Construction Bid – Addendum A

November 5, 2015

1. **Construction Bid RFI's #4-60** (#1-3 are not applicable to this bid) – List of submitted RFI's and responses, dated 11/05/2015
2. **Exhibit O – Milestone Project Schedule**, data date: 10/28/2015, run date: 11/03/2015
3. **Exhibit H – Alternate Update** – Replace Exhibit H with attached revision, dated 11/05/2015
4. **Exhibit I – Unit Prices Update** – Replace Exhibit I with attached revision, dated 11/05/2015
5. **Stantec Addendum #1** – Inclusive of the following documents:
    a. Addendum #1 Drawing & Spec list, dated 11/02/2015
    b. Revised drawings, dated 11/02/2015
    c. Revised specifications, dated 11/02/2015
6. **As-Built Drawings** – 1972 as-built drawings provided for reference only (All contractors are to verify accuracy with actual in-place conditions).

PENTHOUSE ROOF FRAMING PLAN

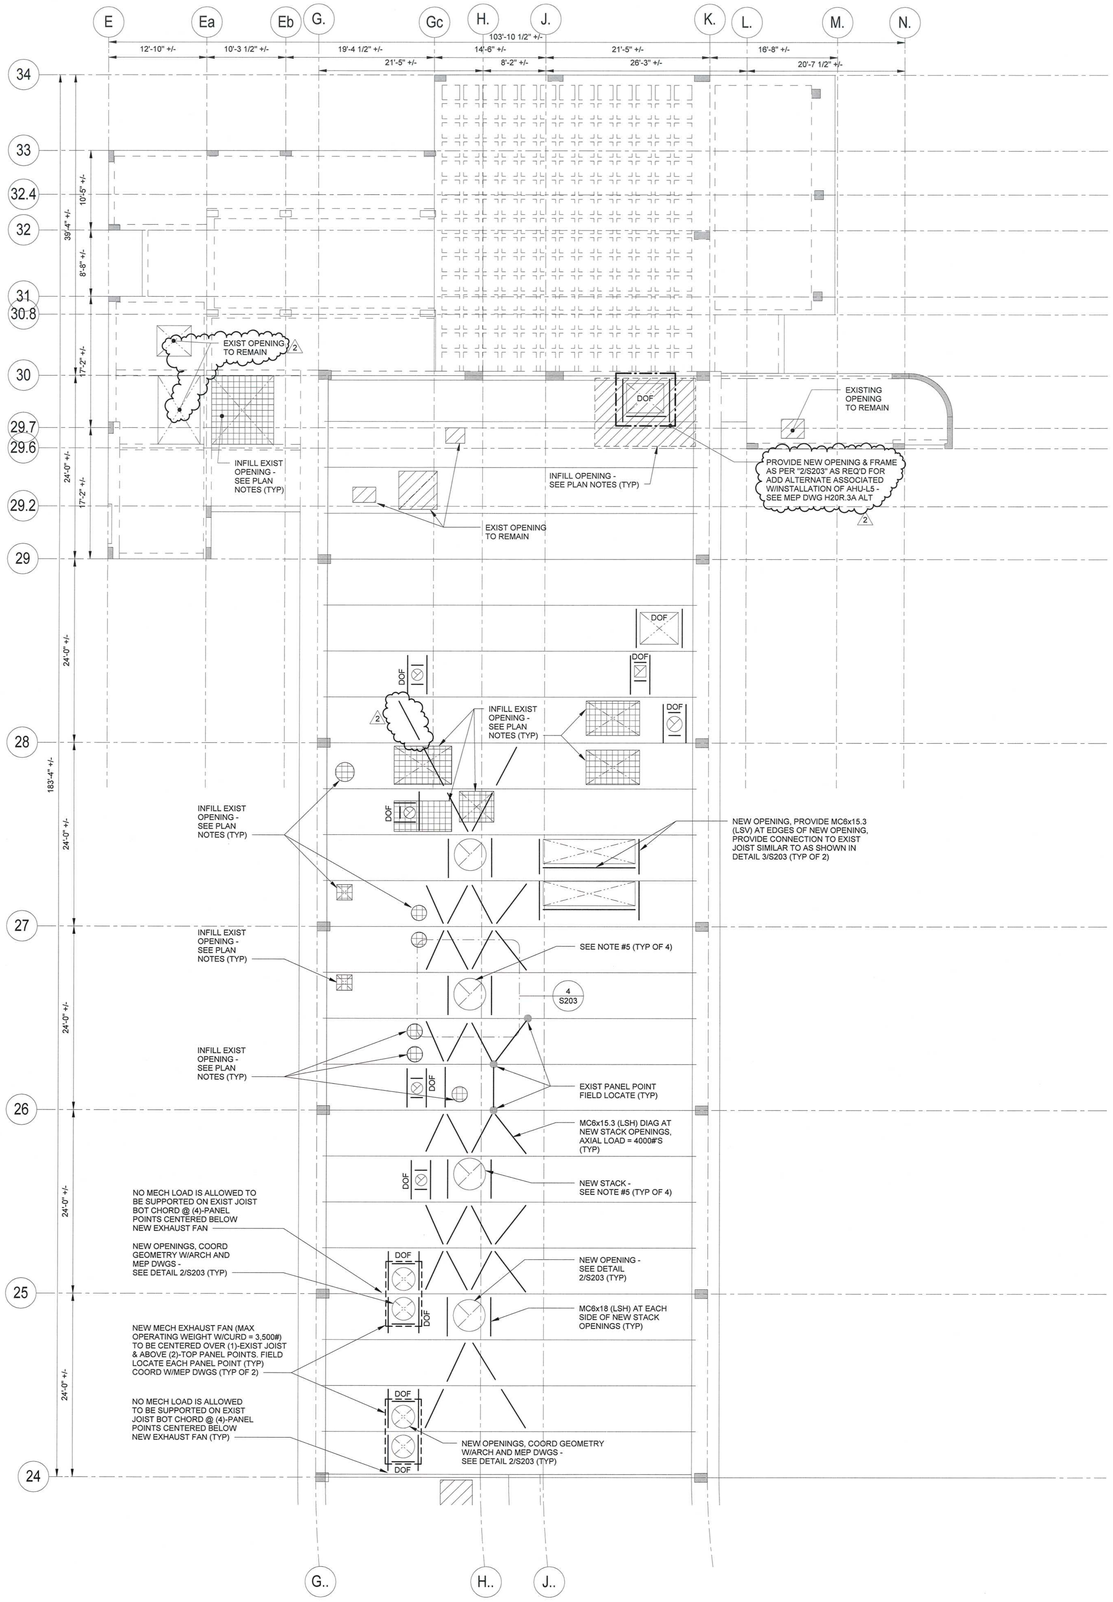
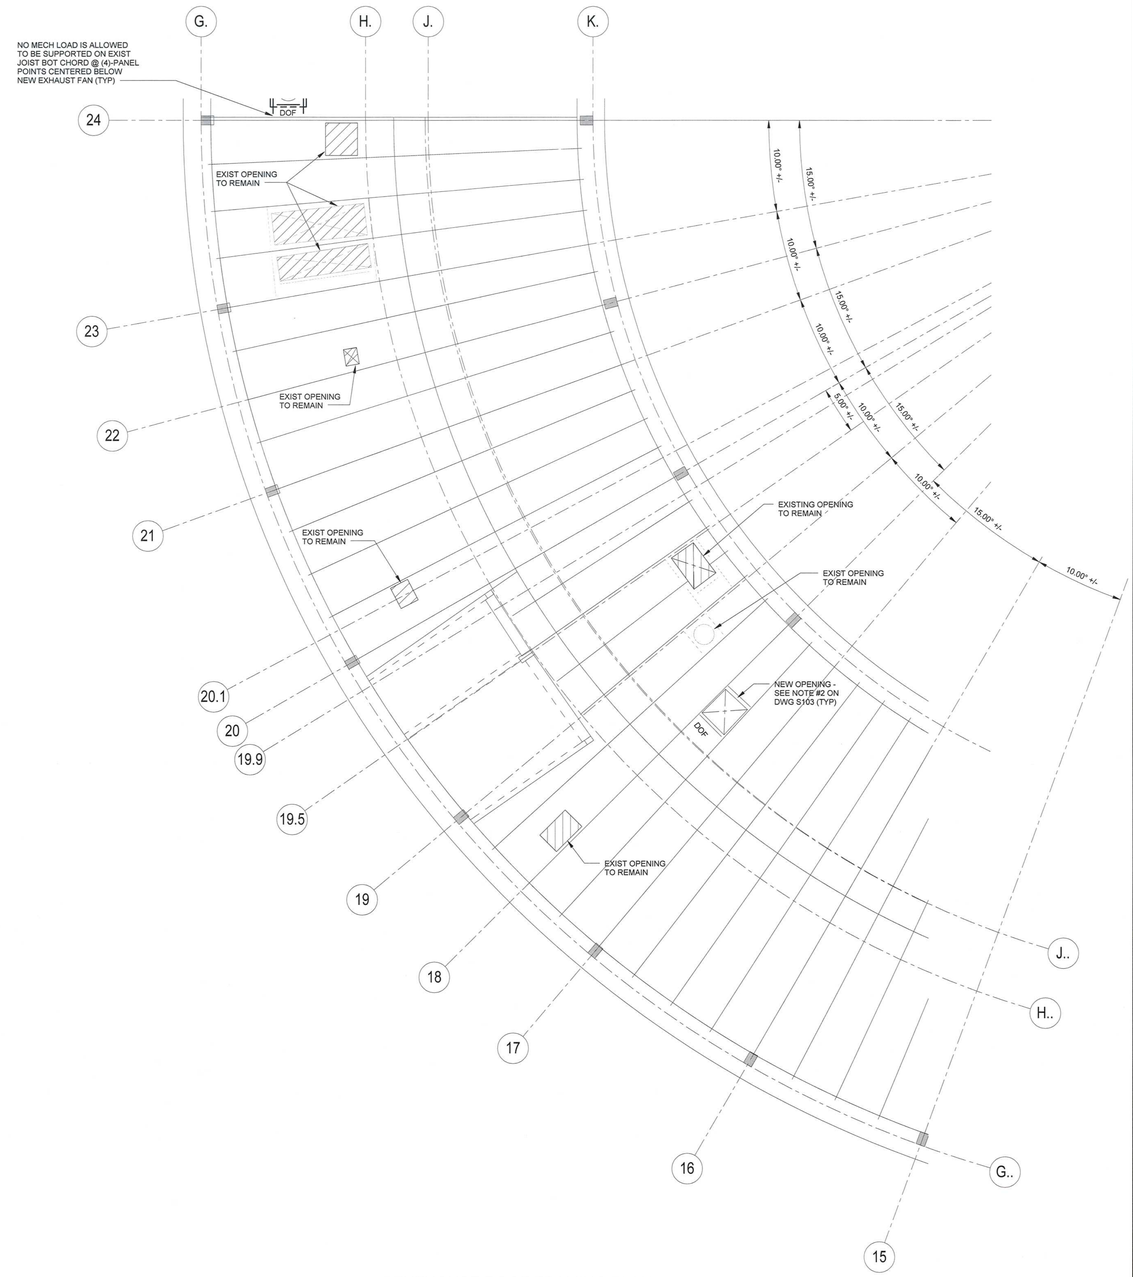
- Any contractor supporting from the existing open web joist system is required to follow the requirements of Note 3 on Drawing S103 inclusive of all required engineering.

1 (A104.3A) 4th Floor - Demolition - Pt1

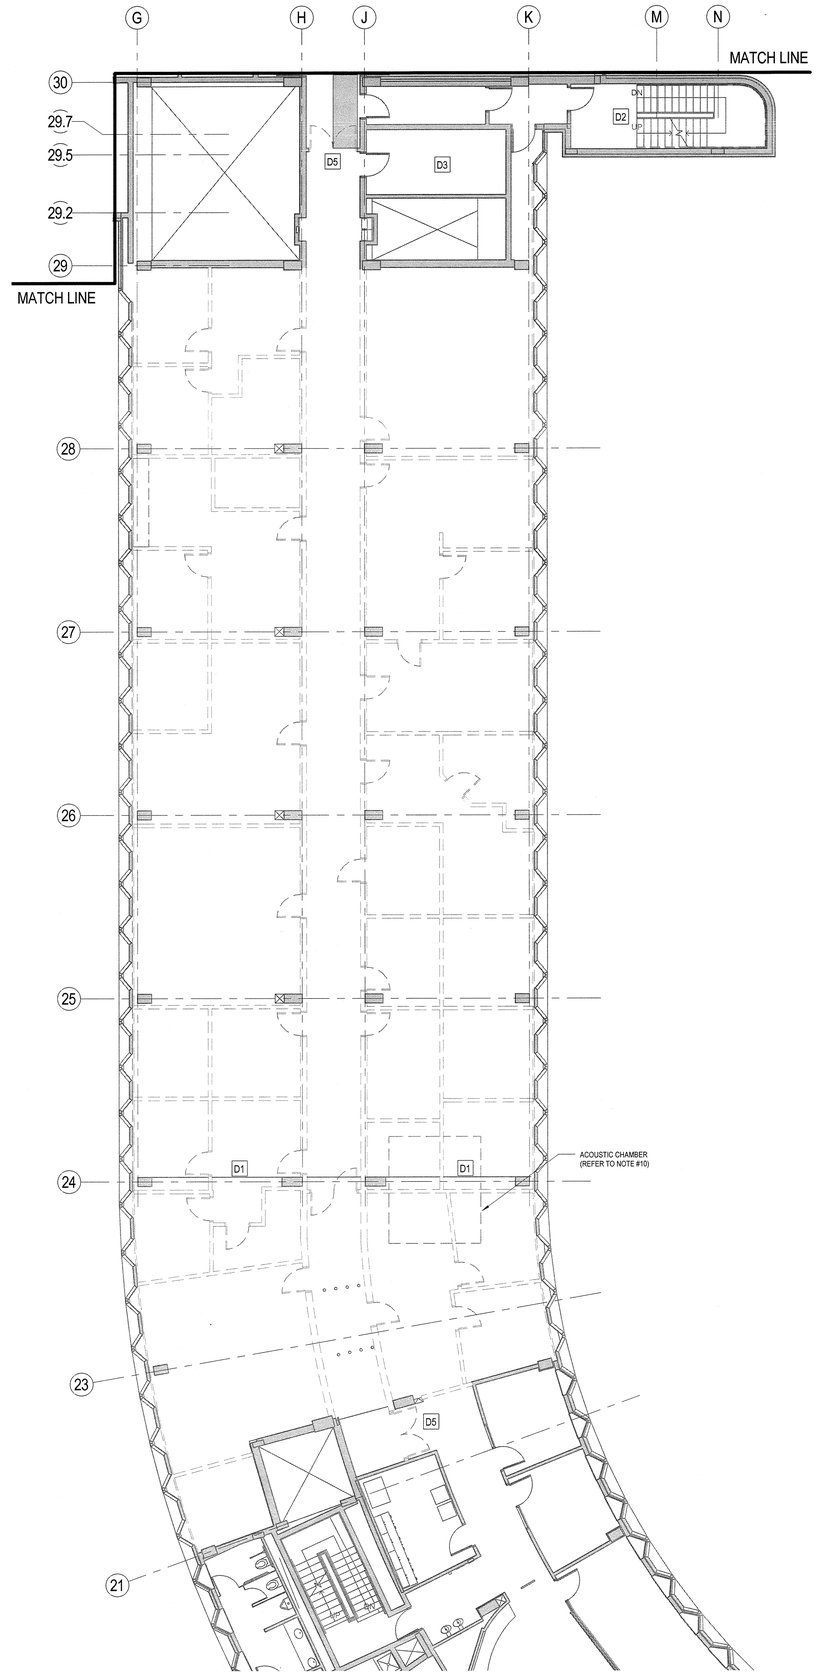
- Provide selective removal and reinstallation of existing ceiling systems in the 4th floor lobby and on the 3rd floor as indicated on Drawings A104.3A and A133.3A. Perform all work off-hours and coordinate with Whiting-Turner and other trades as required.
- Furnish and install all automatic door operators. Coordinate work with other trades as required.
- Provide plywood backboards for electrical and data installations per Division 26 and 27 Specifications.

1 A20R.3A **Roof Plan 1**
1/8" = 1'-0"

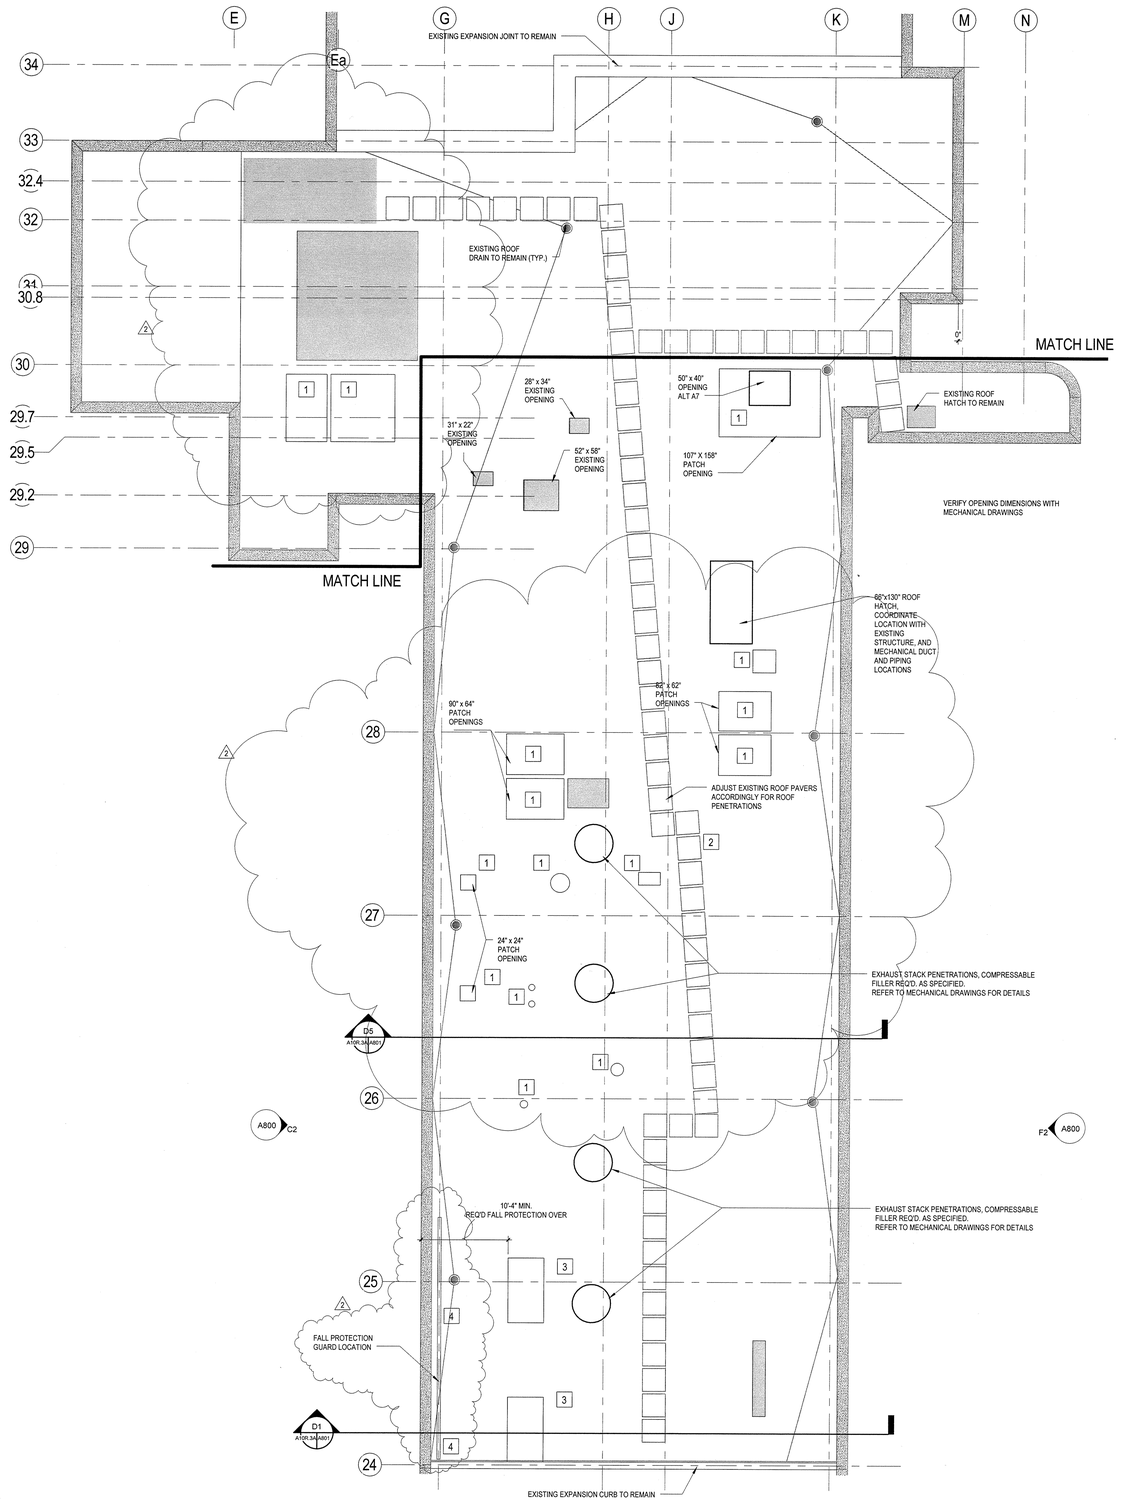
RFI #	Document Reference	Question	Response to Bidders
14	A20R.3A	Please provide design for fall protection required by Keynote 4 on Drawing A20R.3A.	Refer to drawings A802 in Addendum #1
15	4/S202	Detail 4/S202 shows a new railing at new concrete curbs. This railing is not detailed on the architectural drawings as noted. Please provide detail for this rail.	Refer to sheet A802 and A20P.3A in Addendum #1
16	A204.3A	General Note 12 on A204.3A says to "Maintain" floor slab and slab edge fire rating, inferring that a rating exists. Please clarify if a rated system exists and, if not, to what extent are we to install the new fire resistive joint system shown on E5/A255?	Response to be provided in next Addendum.
17	E5/A255	Detail E5/A255 shows a fire resistive joint system between existing floor slabs and the precast concrete exterior wall system. The installation appears to be available only from the floor below. Installation of this detail at the 4th floor slab would require extensive demolition on the occupied 3rd floor. Please provide an alternate detail that can be installed from above each floor slab, or confirm installation of this detail will not occur at the 4th floor edge of slab.	Response to be provided in next Addendum.
